Notice of public question (Procedure Rule 10) – Executive 7 May 2024

1. Question from Catherine Powell, Surrey County Councillor for Farnham North;

Figure 42. Proposals for Cycle Route 3

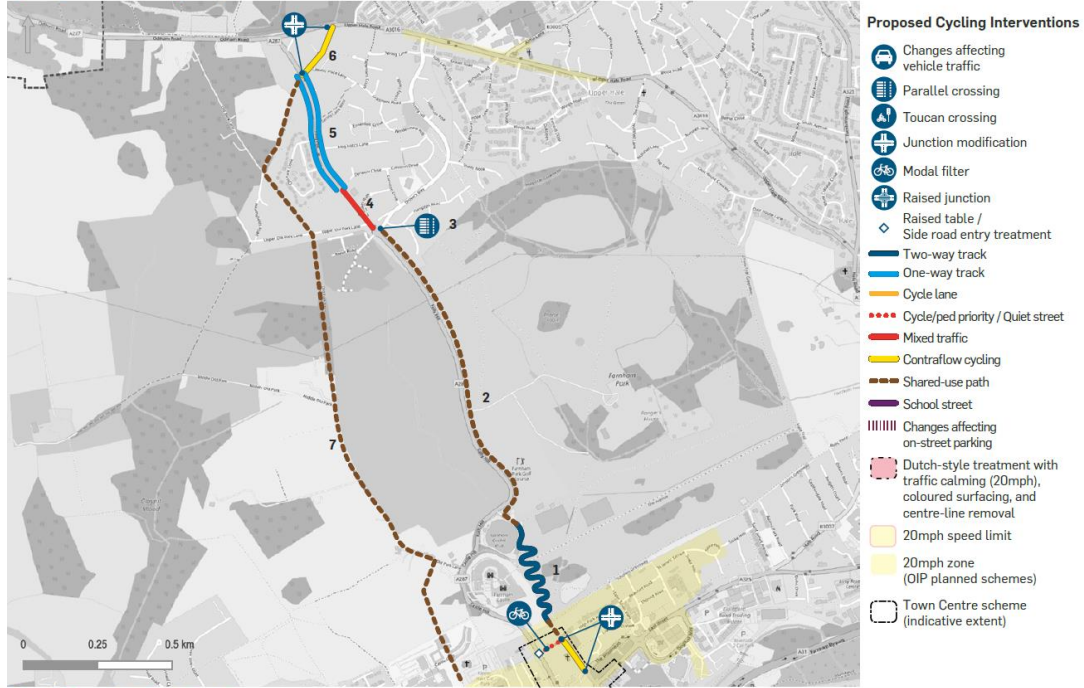
- c. In the case of the “Castle Hill Realignment”, do not address the concerns raised in the public consultation meetings in the Summer / Autumn of 2023 and will instead cause further confusion. Cycle Route 3 (see map below) was reviewed during the Summer Public engagement sessions and the route along Old Park Lane was preferred to the route along Folly Hill and adjacent to the Castle. The Old Park Lane Route was included in the priority routes. The WBC Officers have I believe argued that the Castle Hill Realignment addresses the concerns raised regarding impact on archaeology and ecology associated with that route. However, as can be seen in Figure 1 below, this is not the case, as well as archaeology there are also ecology and safety concerns.
